Gila Mining, LLC P.O. Box 444 Deming, NM 88031 October 31, 2020

RE: Agency Review Comments and Request for Additional Information, Peru Mill Tailings Minimal Impact Exploration Project Modification 20-1 Application, Permit No. LU038EM – Luna County, New Mexico

Project No.: 2020-1 Date: October 2020	Project: Peru Mill Tailings	Drining Application	Figure 1 Surface Impact Map
Drawn by: ETJ Reviewed by:SPF	Gila Mining, LLC	Amendment Response Comments	Guriago impage map

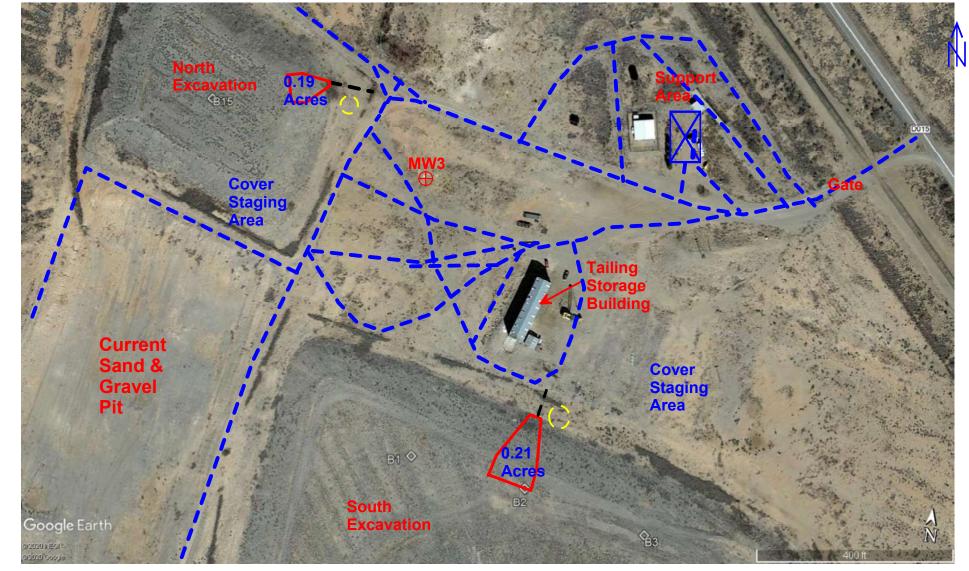
2. Section 4.F of the application states the new roads will not be reclaimed. MMD will require all disturbance including new roads to be reclaimed.

Reclaiming the new roads on the property presents a problem because much of the area between west of the building and east of the north pile has been disturbed by the current aggregate mining that is on-going south of the north stockpile. As part of the Application, GM attached to this letter Figure 1 titled "Surface Impact Map" attempted to illustrate current road network. For the record, the aggregate company doing the mining of the sand and gravel are maintaining the main operation road that intersect GM's leased property but short cuts are taken across the area between the north stockpile and the building. As part of GM response to comments, GM has re-examined its planned extraction locations and moved the north stockpile excavation area north of the original Application area as illustrated on the attached Figure 2. The area impacted has been expanded due to issues of a 3:1 slope in the excavation and the request for berms by MECS. Areas to minimize the excavation time and further minimize the impact to the cover and minimize road expansion. Nonetheless this change reduces the additional road impact to the Site. It must be emphasized, for the record, that these road extensions are not on the tailing stockpile and the property surrounding the stockpiles are relatively sparsely vegetated when compared to the vegetation on the stockpile. Once the tailings have been extracted the roads will be graded back to original condition including seeding and mulching. Any spillage from the truck (not expected) will be cleaned up prior to reclamation. Original condition and post excavation will be photographically documented. GM will follow the same reclamation procedures that was completed for the access way to the north stockpile for the original drilling assessment.

Figure 2 **North Stockpile Excavation Info**

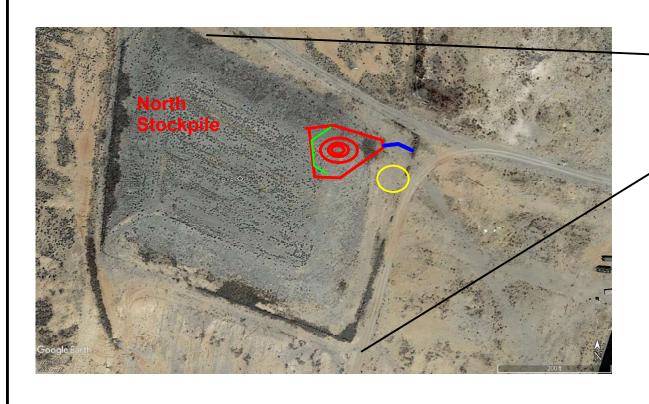
1. Section 4.C provides dimensions for both the north and south excavations. The volume calculated using these dimensions is 1,806 yd³ for the north excavation and 20,463 yd³ for the south excavation. These volumes exceed the allowed 999 yd³ that can be excavated under this permit. Please clarify the volume of tailings to be excavated from the north and south piles.

3. The acreages for north and south excavations in the Disturb Area Summary table in Section 4.H differ from the acreages calculated based on the dimensions provided in Section 4.C. Please clarify the correct acreage for the surface disturbance for both excavations.

GM fully understands the limit of the permit and has no intention to remove more than the 999 yd³ as stated in the application and allowed by the permit. Nowhere in the Application Section 4.D does it state or imply that the full 25-foot depth of tailings was planned to be extracted, in fact the Applications Section 7.D GM clearly states only 999 yd³ will be removed and stockpiled in the building. The permit application Section 4.D presents the requested estimated dimensions of the proposed excavation and not the volume of the tailings that will be removed. Obviously, GM has no plans of removing the full thickness of tailings at either of the proposed locations. Currently GM plans to remove approximately 399 yd³ from the north stockpile and 600 yds3 from the south stockpile. See our response Section 7 for GM's planned method of measuring the volume that will be removed from each excavation.

Excavation Area Estimate: $(83.3 \times 50) + ((83.3 \times 100)/2) =$ 8,333.33 ft2 or 0.19 acre

Road dimension = 50 ft x 10 ft = 50 ft2 or 0.012

Figure 4: Peru Mill Building

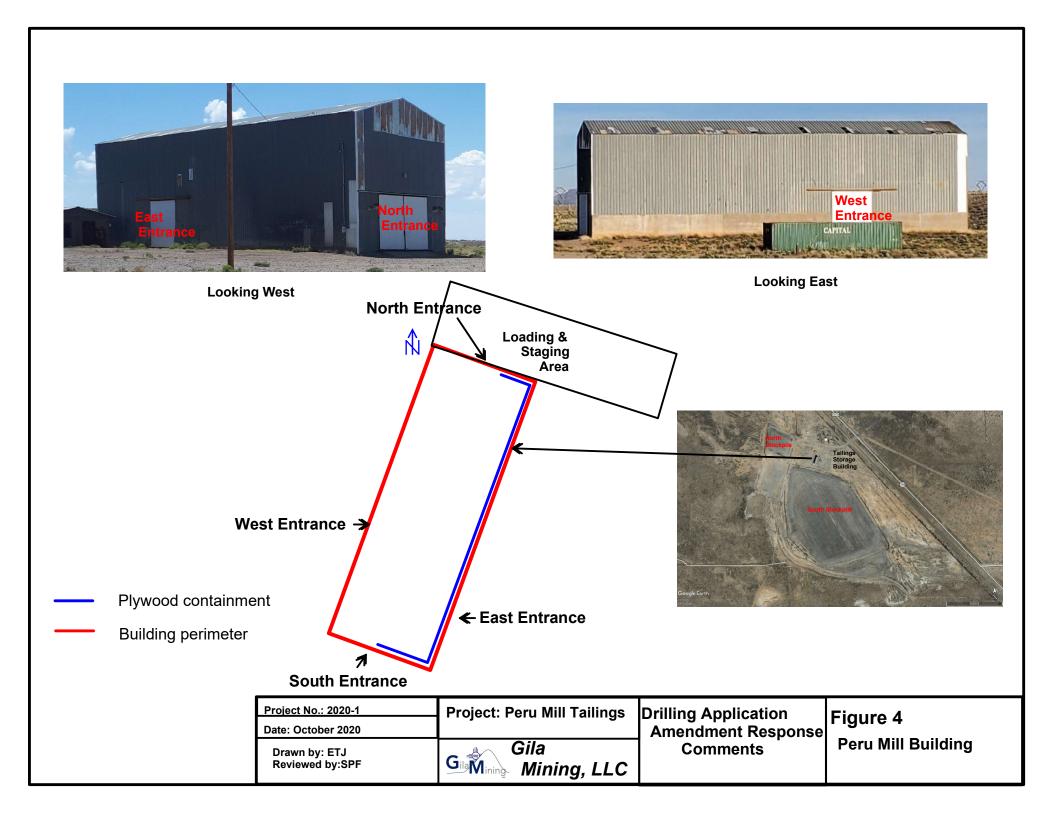
6. MMD Section 7.D states "plywood barriers are planned along the walls if the tailings in the building exceed the height of the exterior walls." Please explain in more detail how plywood barriers would be used and provide either images or diagrams indicating where the plywood would be. MMD's understanding is the building that is to be used to store tailings has walls that reach the ceilings.

The building has poured concrete three-foot high foundation wall on the east perimeter of the building and a seven-foot poured concrete wall on the west side of the building as illustrated by Figure 4. The purpose of the plywood is to for additional containment of the tailing within the building. For further understanding of the purpose of the plywood containment please review the explanation in Section 1 of this response letter.
